KEK			Reference drawing				
DRAWN	NAME	DATE	PROJECT				
	Uchiyama	2025/06/13	COMET				
	CHECKED		DRAWING NO.				
APPROVED			Fig. 1-2(1)				
MATERIAL		SURFACE		TITLE			
Rolled C10200		Buff polish Ra 3.2		Copper Shield L			
FILE NAME			SHEET SIZE	SCALE	PROJECTION	VERSION	シート
ShieldMain_Cu_1_v3.ipt			A3	1 : 10	3rd ang.	3	1/3

KEK			Reference drawing				
	NAME	DATE	PROJECT COMET				
DRAWN	Uchiyama	2024/07/22	DRAWING NO. Fig. 1-2(2)				
CHECKED			TITLE Copper Shield R				
APPROVED							
MATERIAL		SURFACE					
Rolled C10200		Buff polish Ra 3.2					
FILE NAME			SHEET SIZE	SCALE	PROJECTION	VERSION	シート
ShieldMain_Cu_2_v3.ipt			A3	1 : 10	3rd ang.	3	2/3

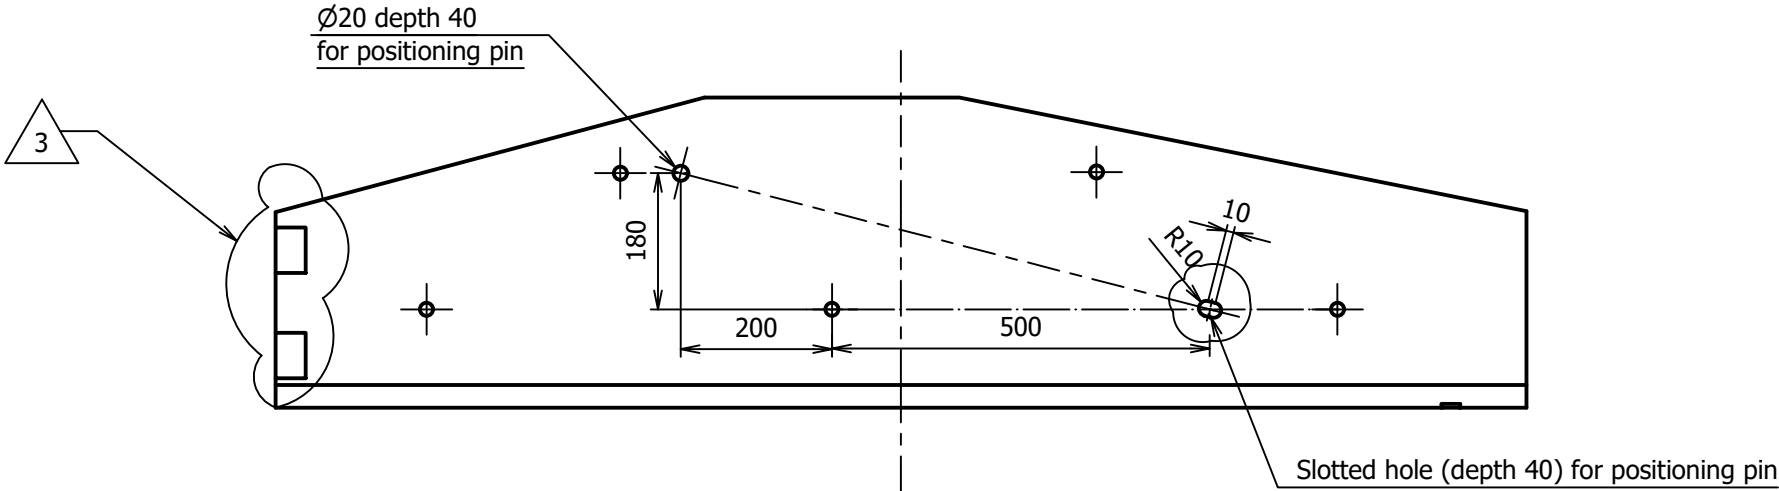
変更履歴		
REV	DESCRIPTION	DATE
1		2025/01/09
2		2025/03/19
3	Correct positions of the pin plates	2025/06/13

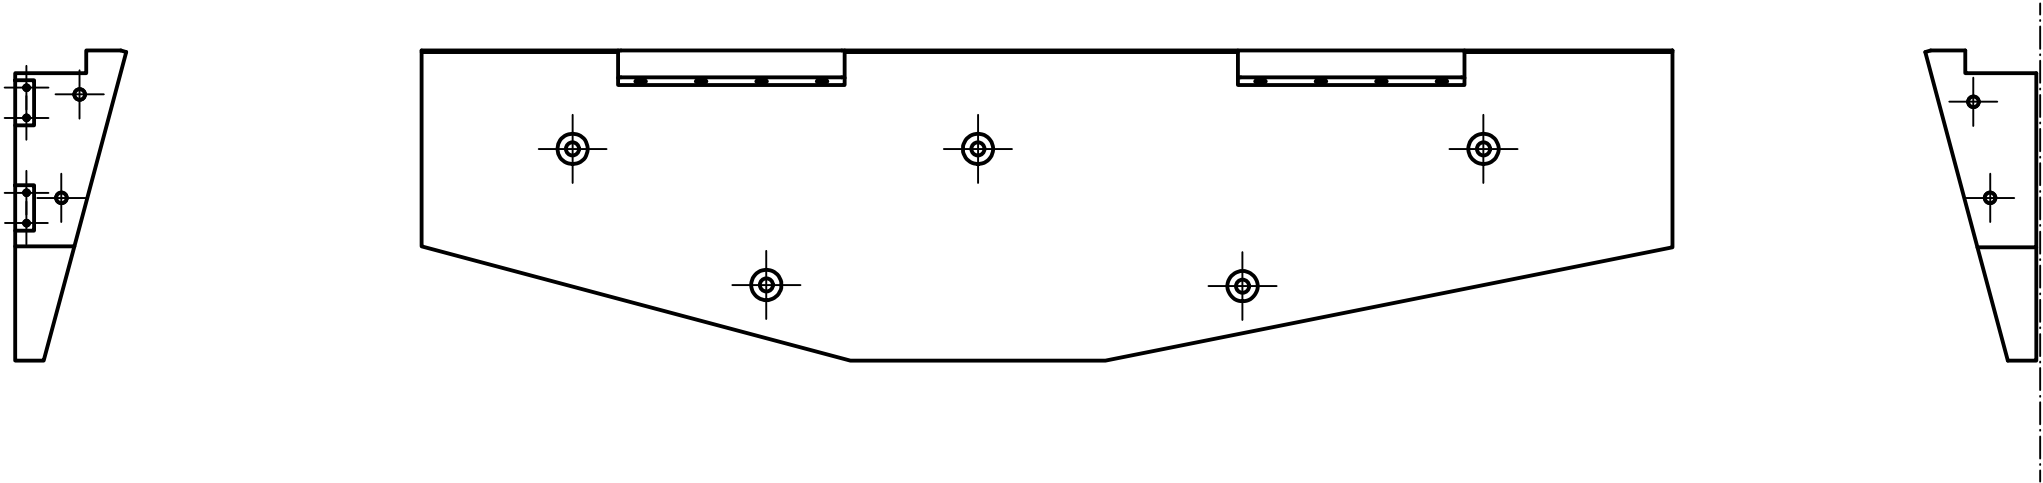
This long hole seems not reflected in your drawing.
Please check it again.
